PROPOSED SELF STORAGE FACILITY - WILSON STORAGE

LOT 100, DP 615225
9-13 COOK STREET, FORESTVILLE NSW 2087

SECTION 4.55 SUBMISSION
04 MARCH 2020

Drawing Title PERSPECTIVES			
A1 Scale	A3 Scale HALF A1 SCALE	Date 09.12.2019	Drawn CR
Drawing No 19-029 DA002			Revision C

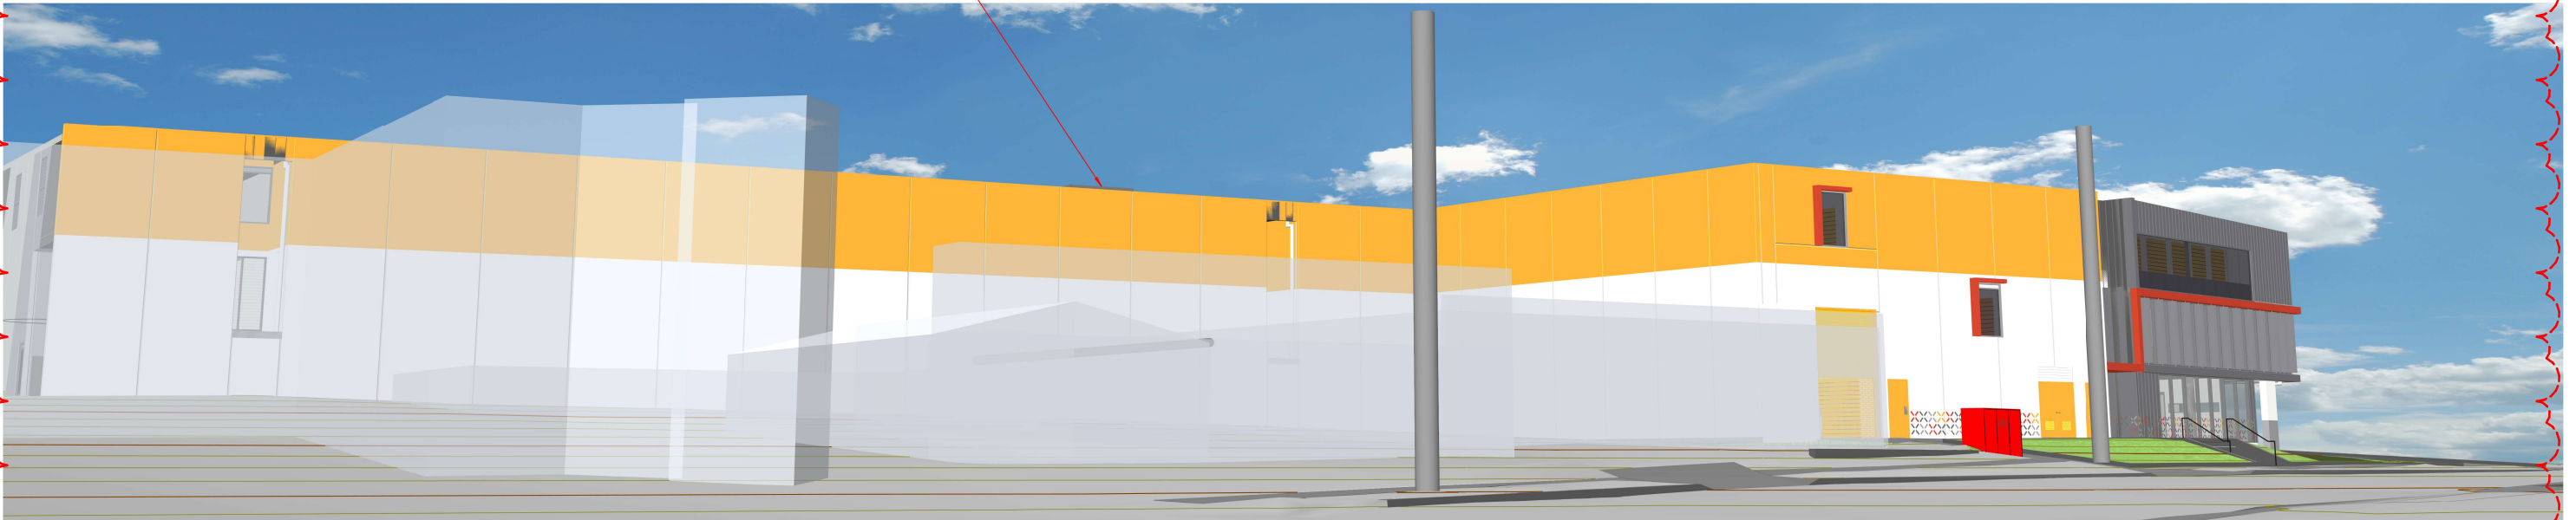
EXTERNAL BUILDING APPEARANCE
AND COLOURS MODIFIED, AS PART
OF THIS SECTION 4.55 APPLICATION

LIFT OVERRUNS NOMINATED
AS PART OF THIS SECTION
4.55 APPLICATION

EXTERNAL BUILDING APPEARANCE
AND COLOURS MODIFIED, AS PART
OF THIS SECTION 4.55 APPLICATION

A1 Scale
1 : 200
A3 Scale
HALF A1 SCALE
Date
05.12.2019
Drawn
CR
Drawing No
19-029 DA201
Revision
C

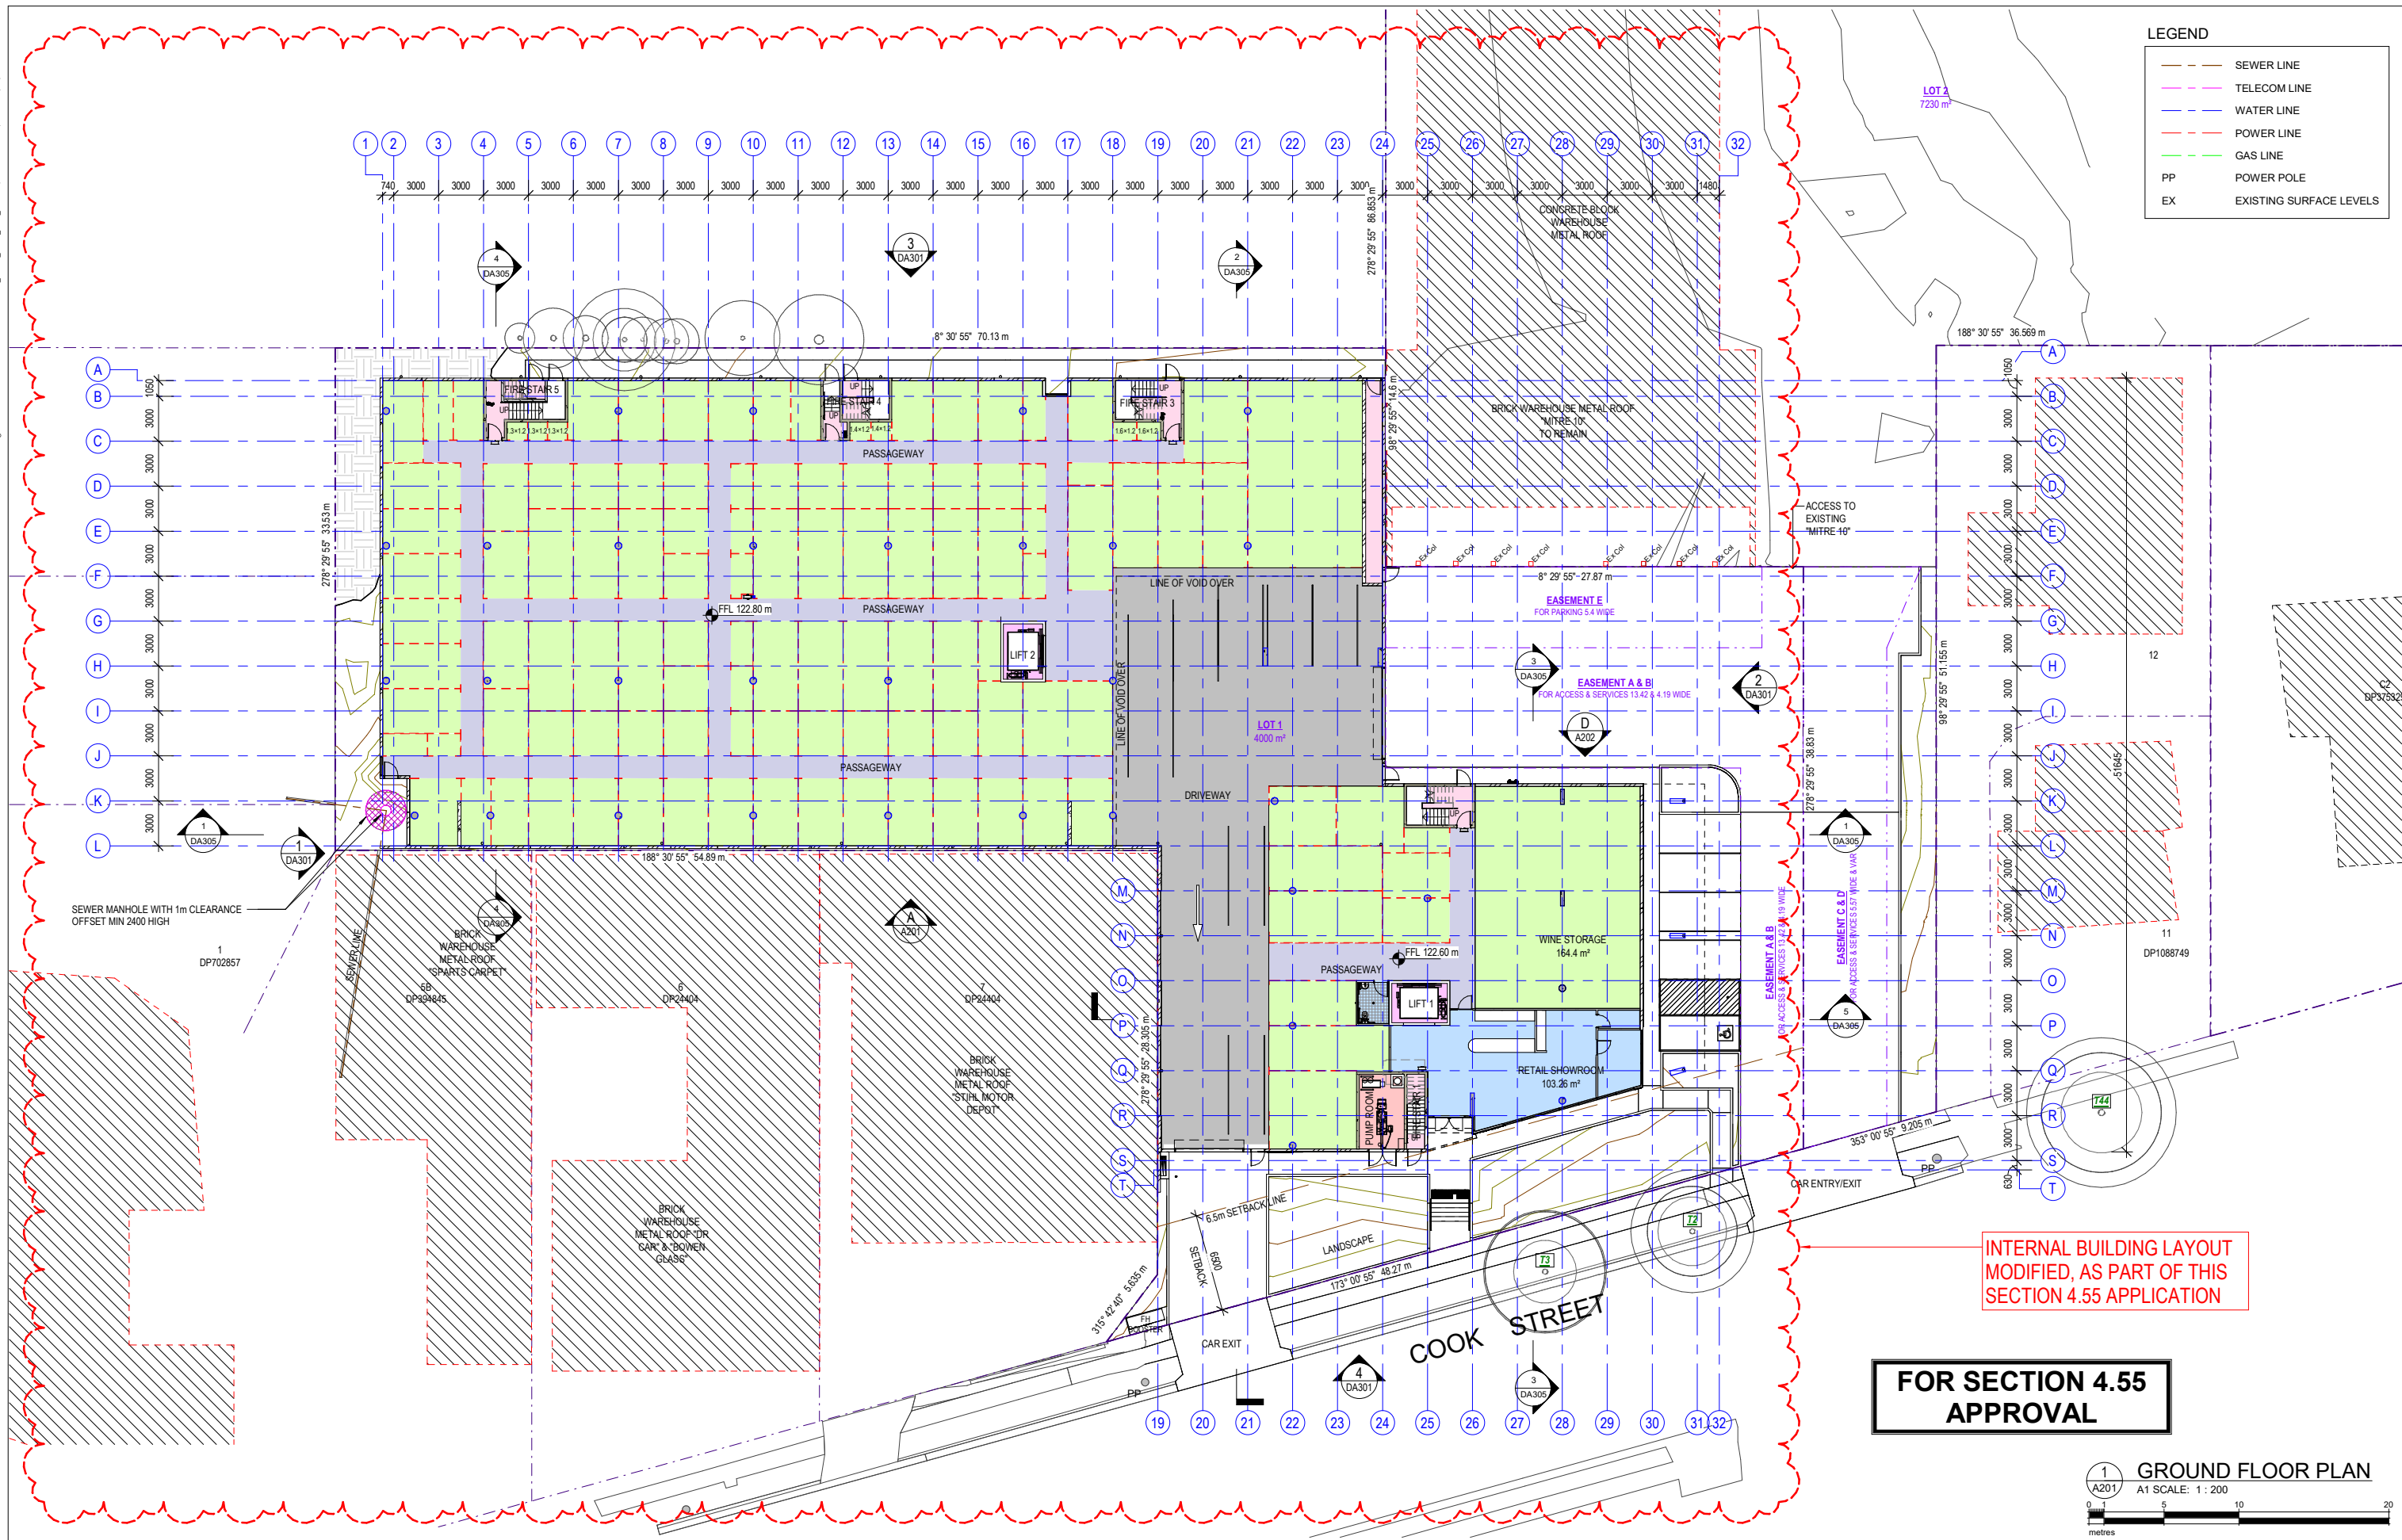
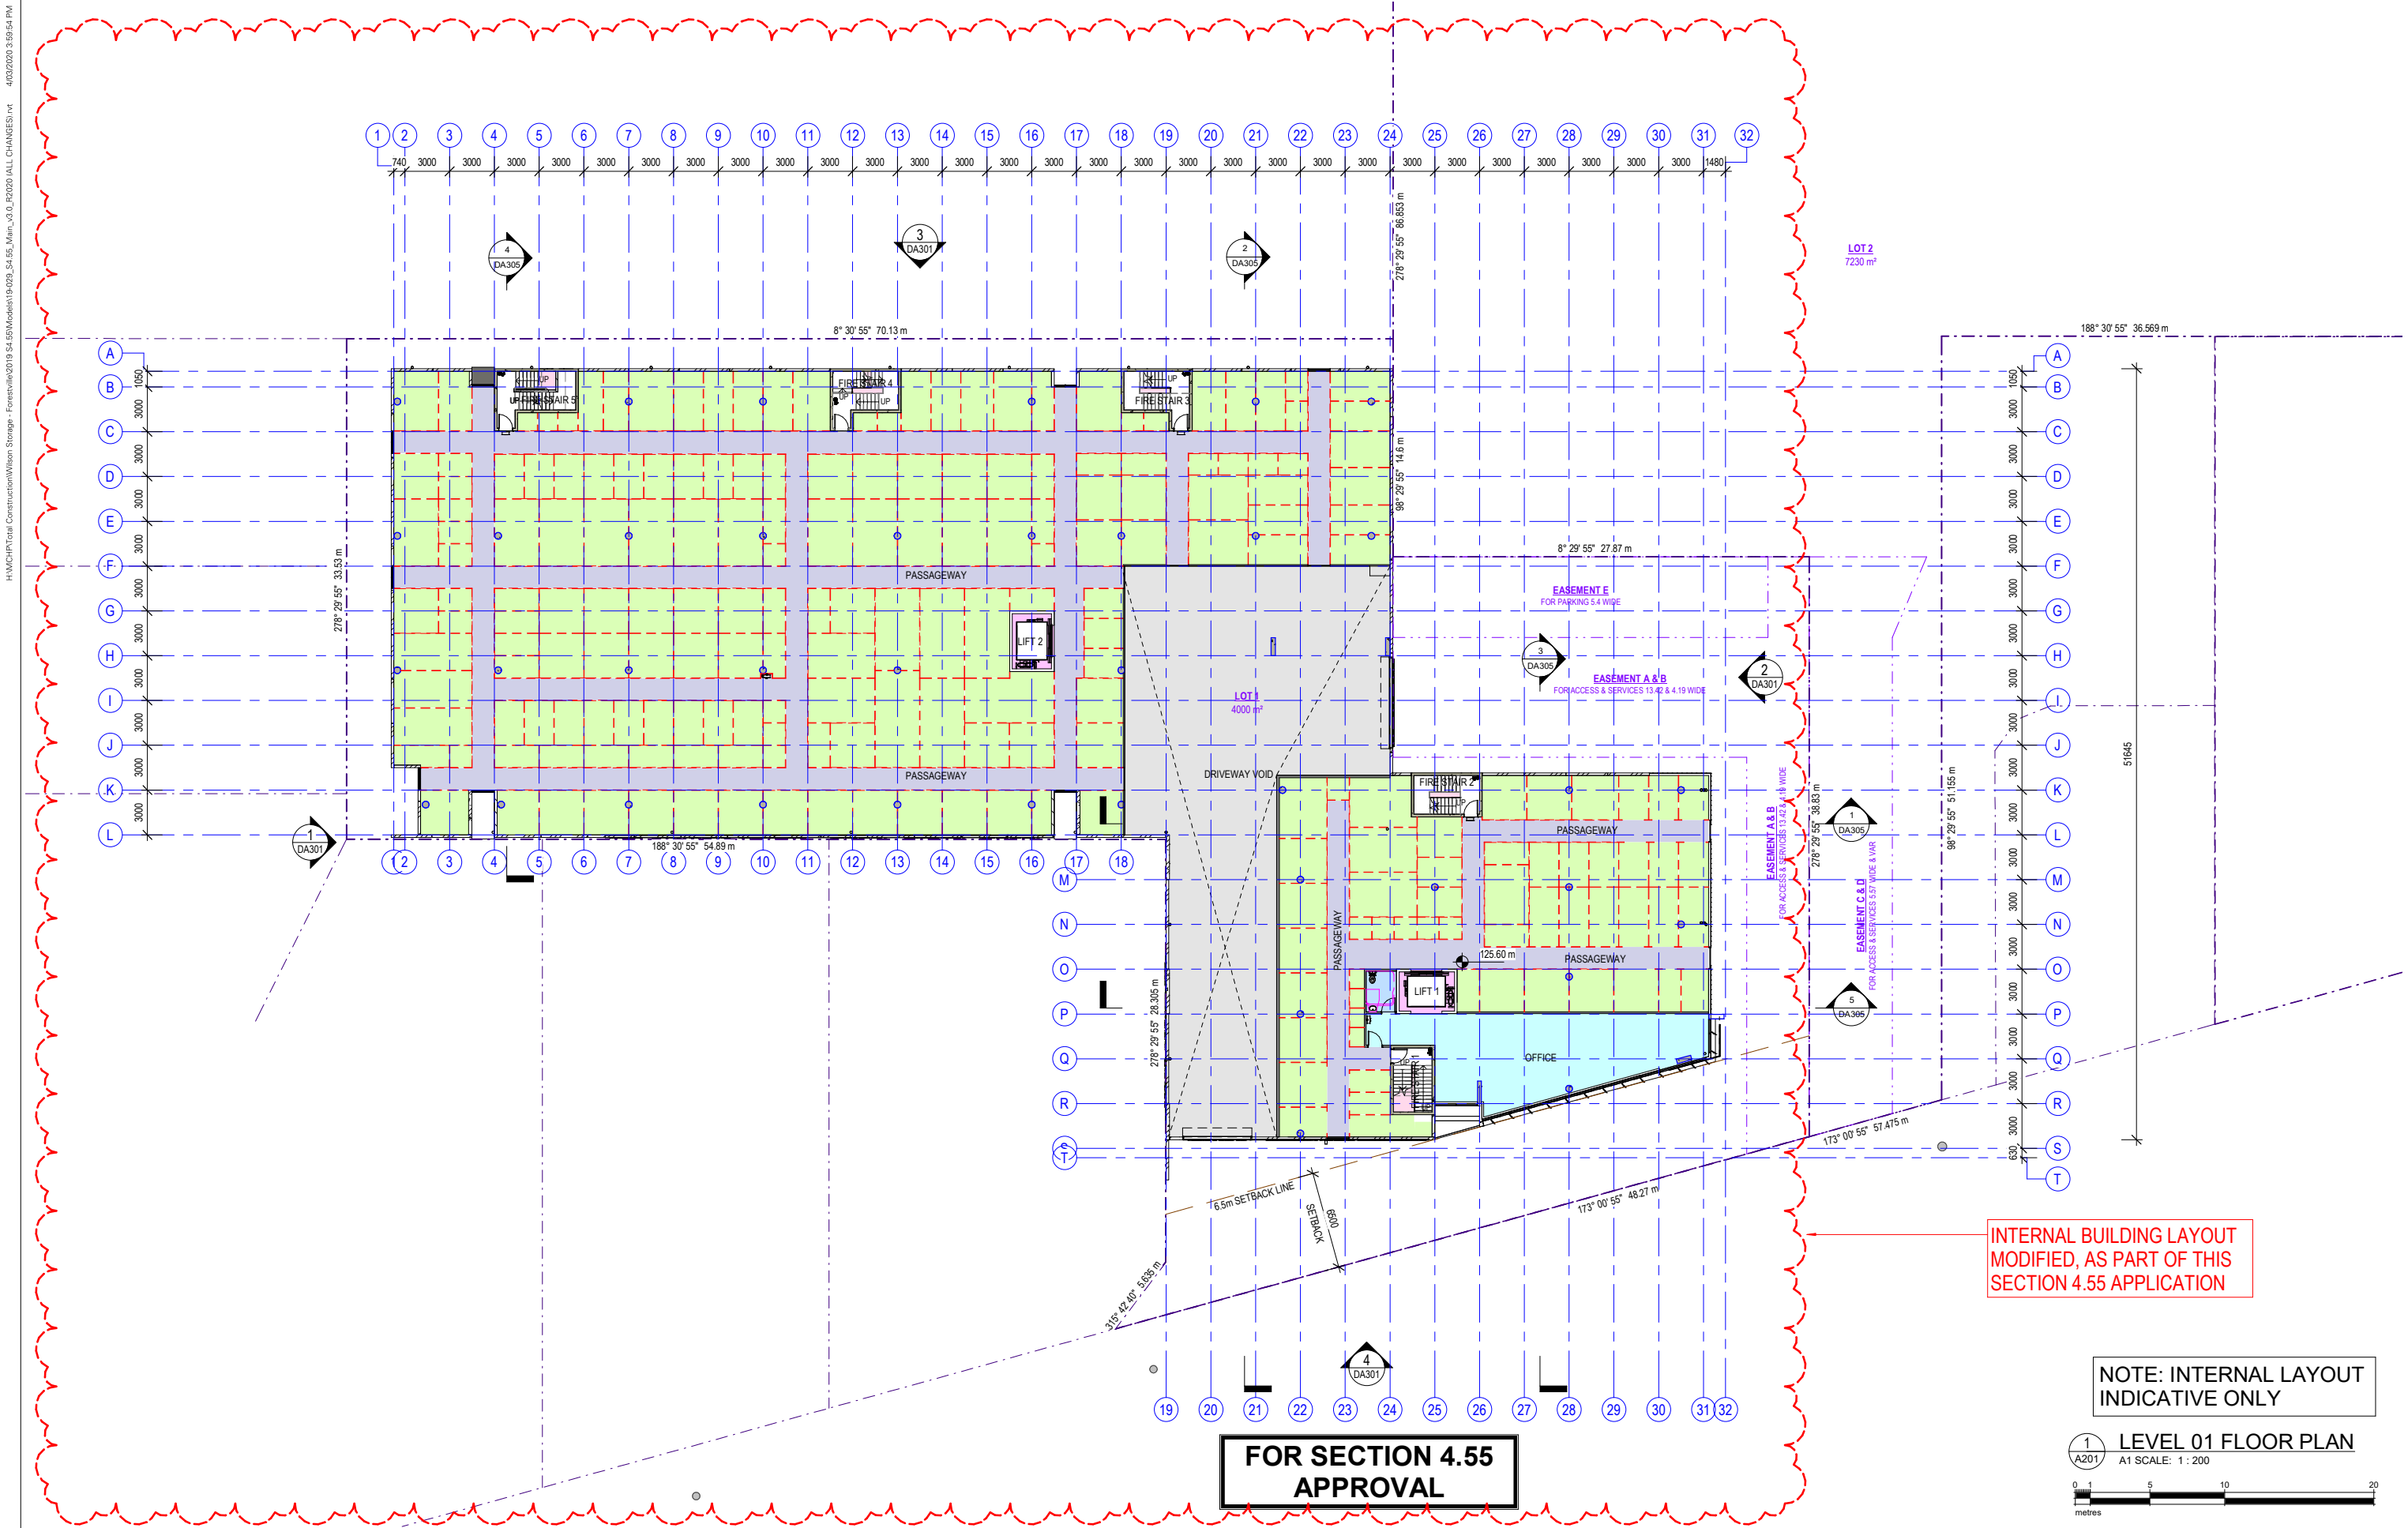
INTERNAL BUILDING LAYOUT
MODIFIED, AS PART OF THIS
SECTION 4.55 APPLICATION

INTERNAL BUILDING LAYOUT
MODIFIED, AS PART OF THIS
SECTION 4.55 APPLICATION
